# TOWN OF FAIRFAX

**SUBJECT:** Discuss/consider the proposed "near term" design improvements of the Parkade in downtown

To: Garrett Toy, Town Manager, Town of Fairfax, California  
From: Matt Taecker, Taecker Planning & Design  
Andrew Lee, Parisi Transportation Consulting  
Date: September 6, 2017  
Re: **Clarifications/Errata for Parkade Circulation & Design Study (August 2017)**

# Appendix A: Table Comparing Options

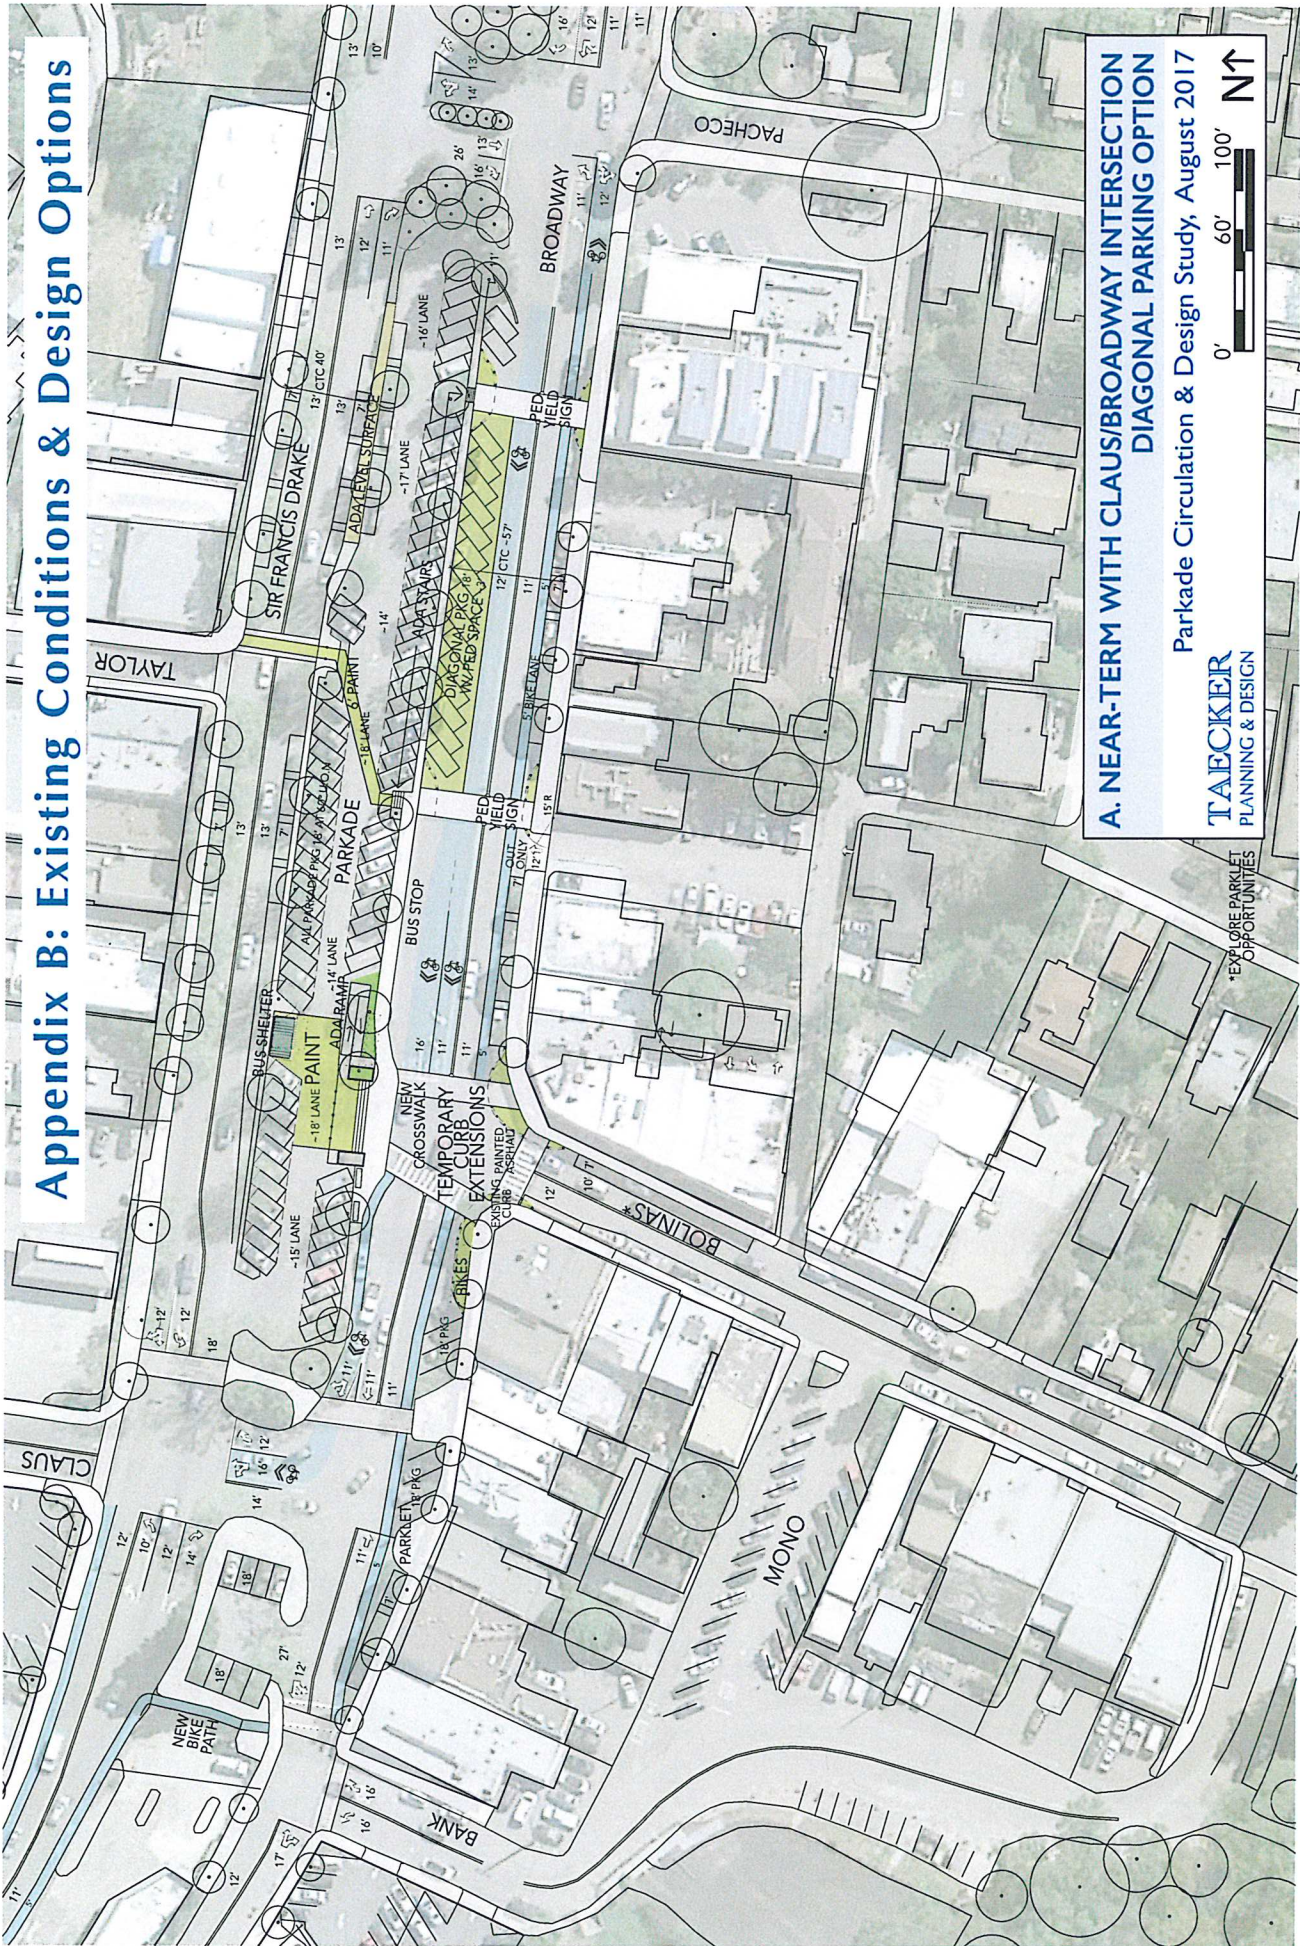
The table shown on page 1,3 and at a larger scale in Appendix A, also incorrectly states that the Claus/Broadway traffic diverter is part of Option A / Near Term. A revised version of Appendix A has been provided for Council's meeting September 6. Revisions to the Study document will also be made for the public record.

## A. NEAR-TERM WITH CLAUS/BROADWAY INTERSECTION DIAGONAL PARKING OPTION

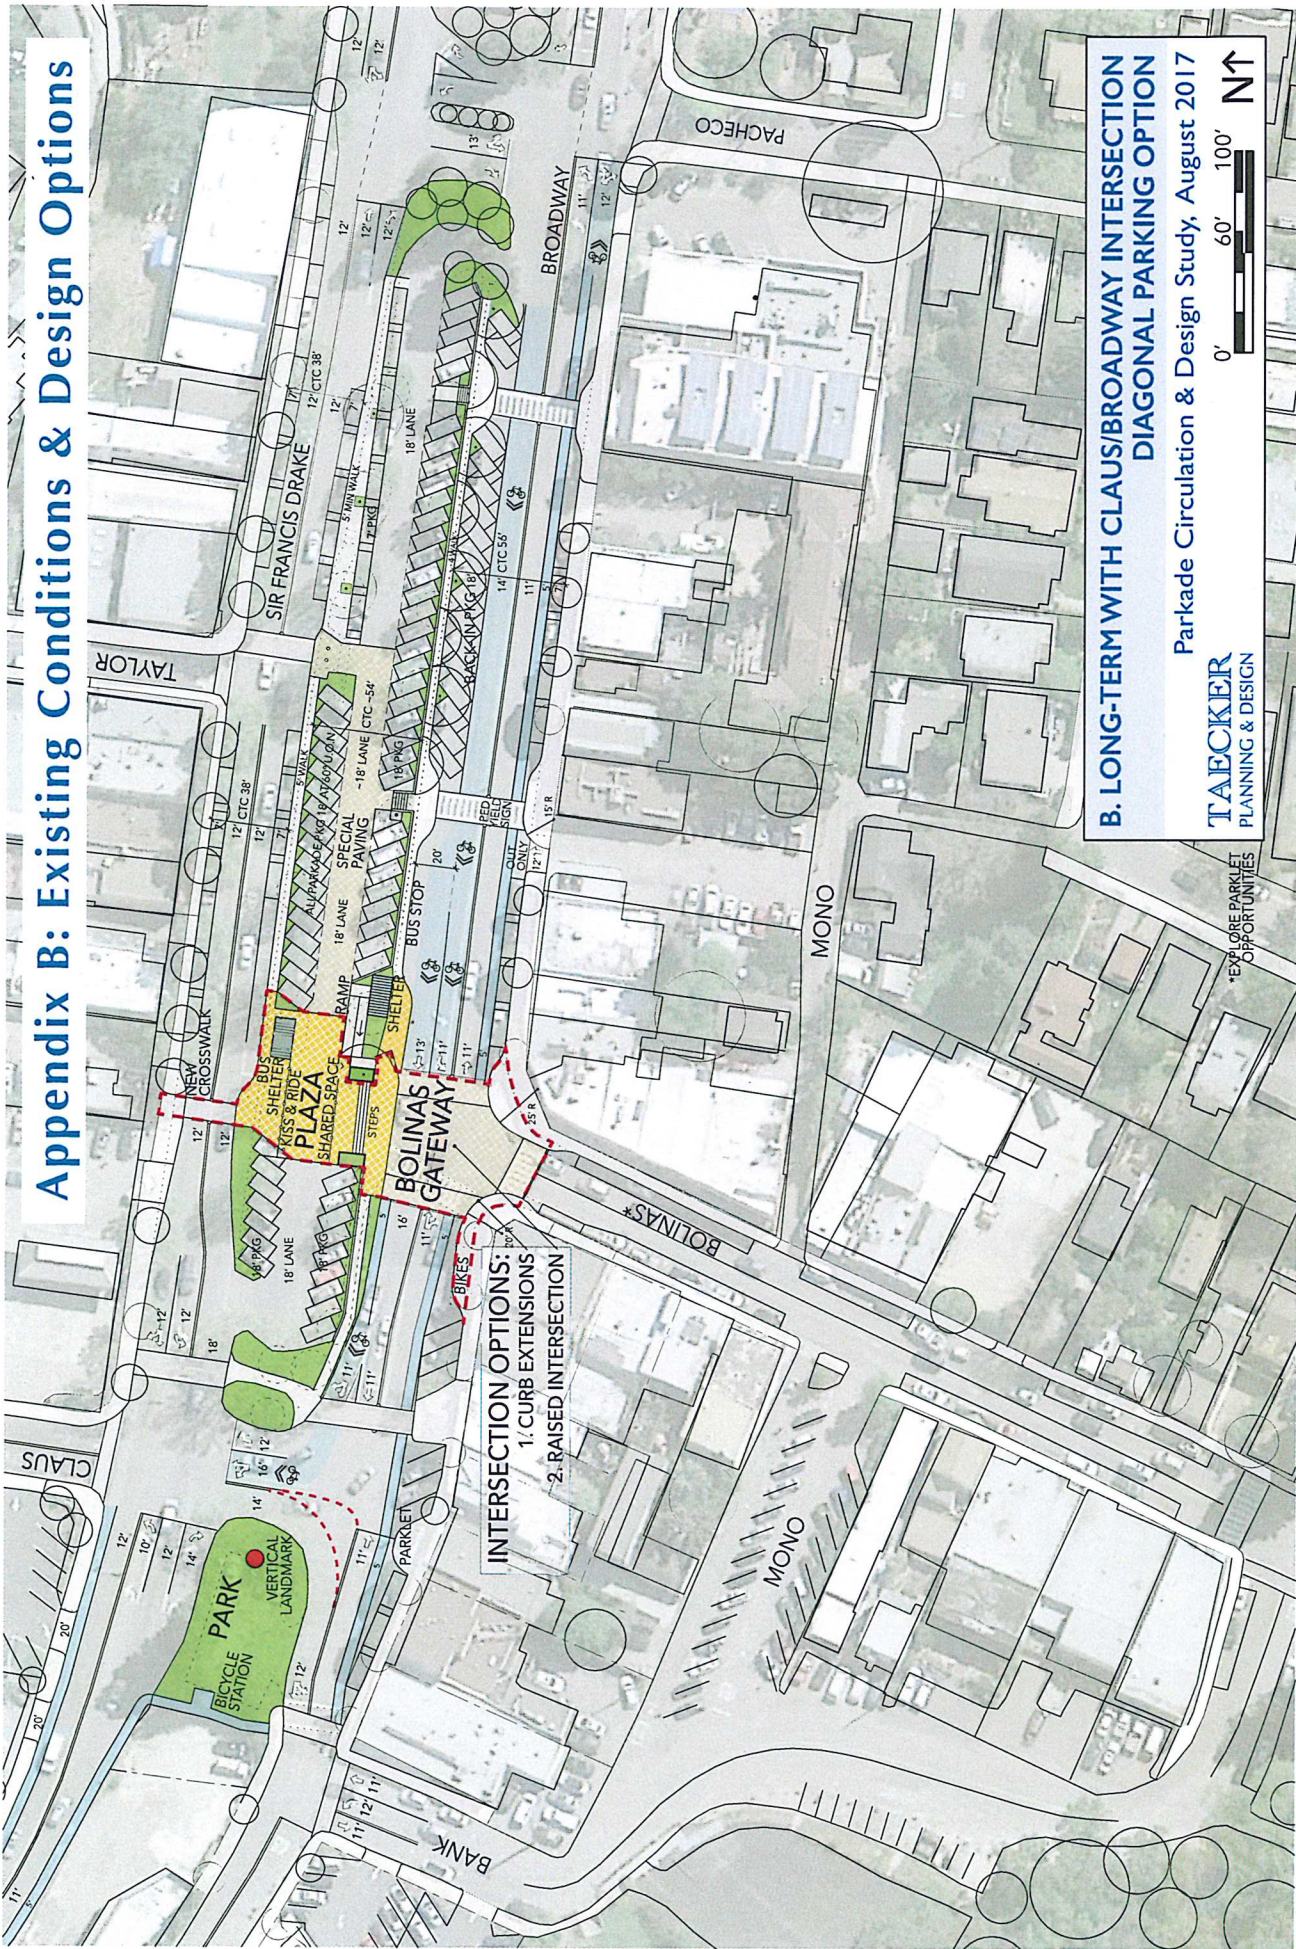
Page 14 and 15. and Appendix B, also incorrectly show the Claus/Broadway diverter in Option A / Near Term. A revised version of Appendix B has been provided for Council's meeting September 6.

**Design suboptions for the northside of Broadway ("Enhanced Sidewalk" versus "Diagonal Parking) are depicted more clearly by displaying on multiple pages.** A revised version of Appendix B has been provided, and separately shows the suboptions for Broadway, rather than showing both suboptions on the same page. These suboptions are shown for Option A / Near Term and for Option B / Long Term. Option C has been dropped, since moving the Broadway and Drake intersections from Claus to Bank has been determined to be infeasible.
